ADDENDUM NO. 2

Raymore Activity Center: Project #17-229-201

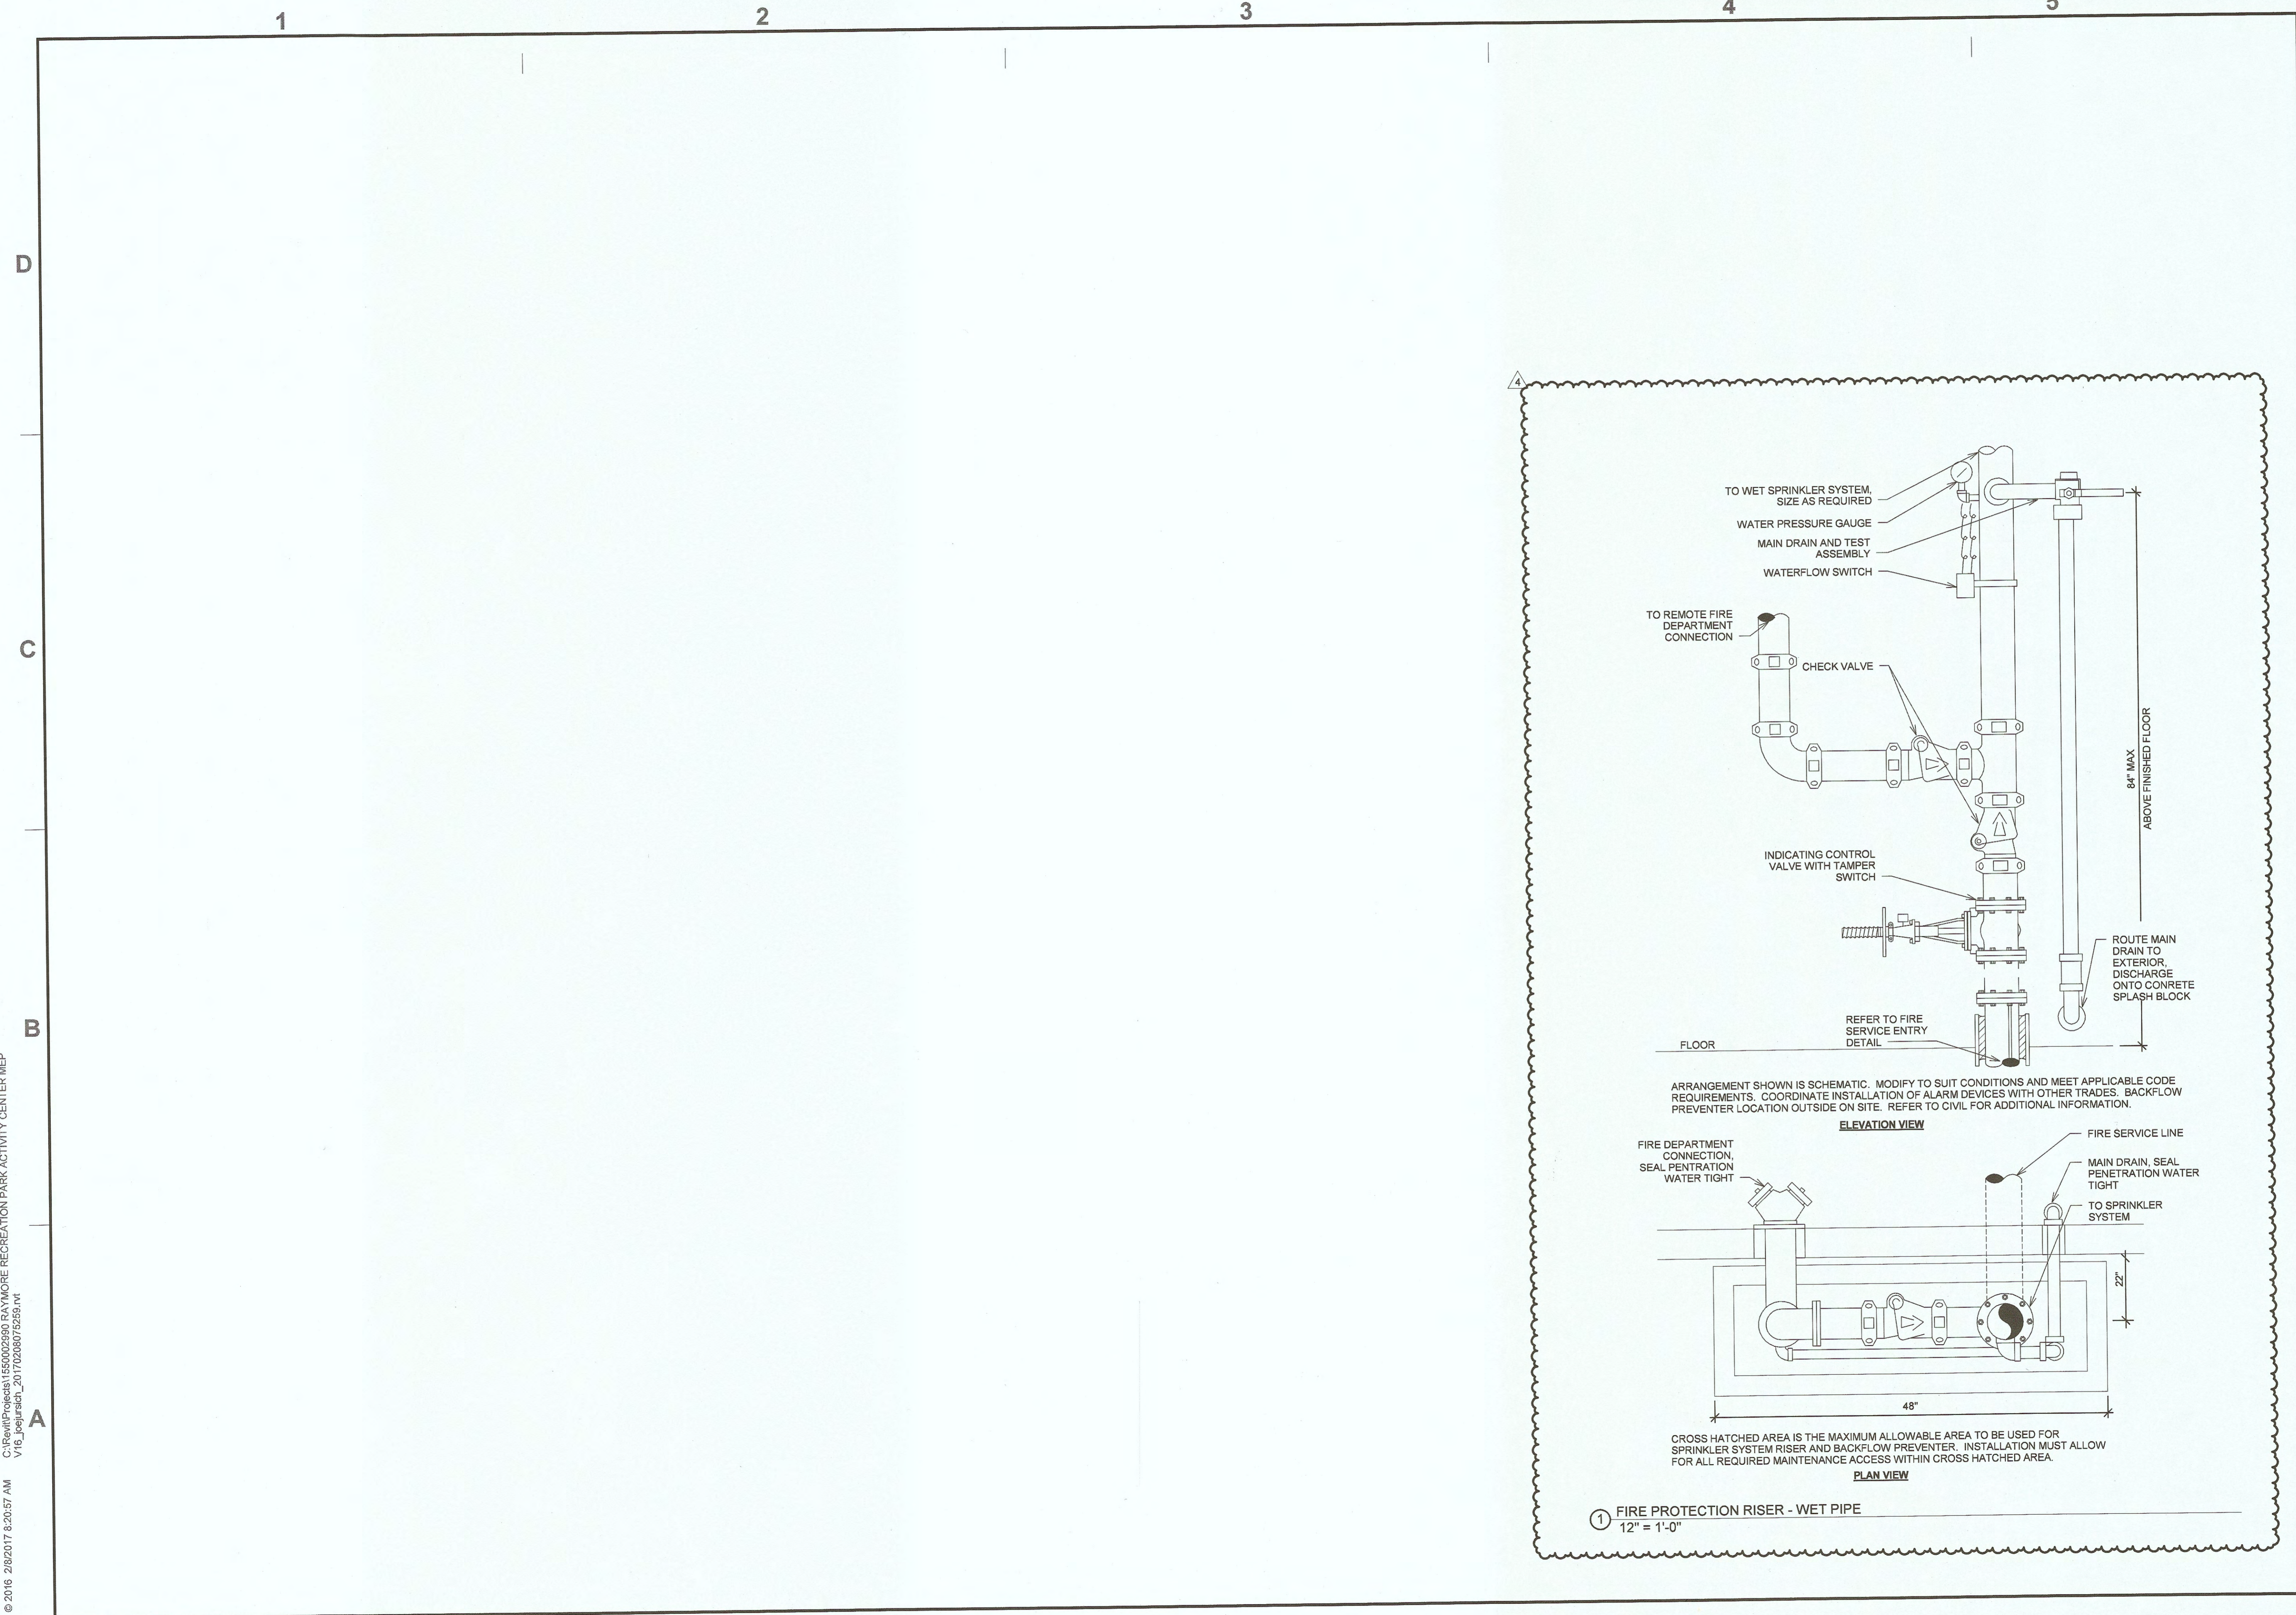
12. **Question:** Is the liner panel above 20' the facing for the simple saver liner.
 - a. **Response:** Yes, this is the simple saver liner.
13. **Clarification:** On drawing C400 there is a fire sprinkler backflow preventer shown on the fire line in vault outside. On drawing FP202 there is a fire sprinkler backflow preventer shown inside on the sprinkler riser. Please indicate as to which location is correct.

- a. Added fixture EM
 - b. Revised description of fixture F4E
- 4. FP202 – FIRE PROTECTION DETAILS (Replace sheet in its entirety with the attached)**
 - a. REMOVED backflow preventer from riser detail.

- a. **Response:** Backflow preventer shown on C400 is to remain. Backflow preventer shown on FP202 inside on the sprinkler riser is to be removed from the project.
